ADDENDUM No. 1

RFP No. 25-38

Screw Pump Replacement Project

**ATTACHMENT 1 TO
ADDENDUM NO. 1
ANN ARBOR RFP No.
25-38**

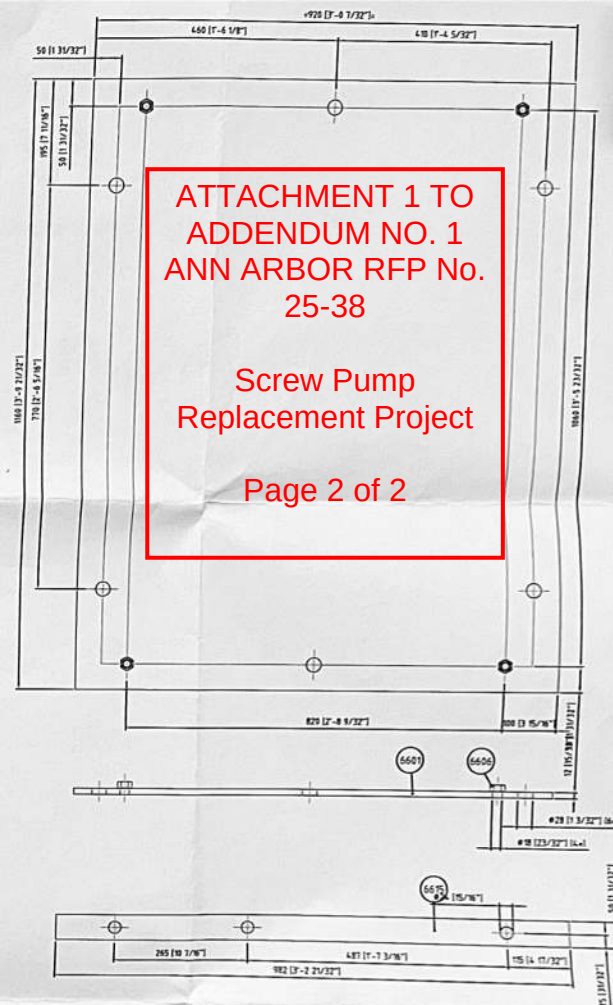
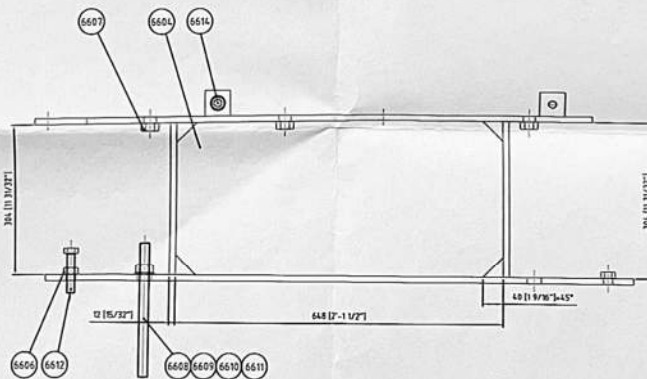
Question 2: See Specification 11310, Paragraph 1.6, Item A.1. If the intent is to evaluate reusing the existing drives for the Raw Sewage screws, please provide O&M drawings, make/model information, and photographs of the gear reducer nameplates for integration purposes.

Question 17: Please verify the Nameplate / Power Requirements for the Screw Pump Motors-1, 2, and 3. Again, the vendors will need this to quote the replacement of the Soft Starters and size them correctly.
 Answer 17: See Addendum No. 1, Attachment A for available record information

Answer 2: See Addendum No. 1, Attachment A for available record information.
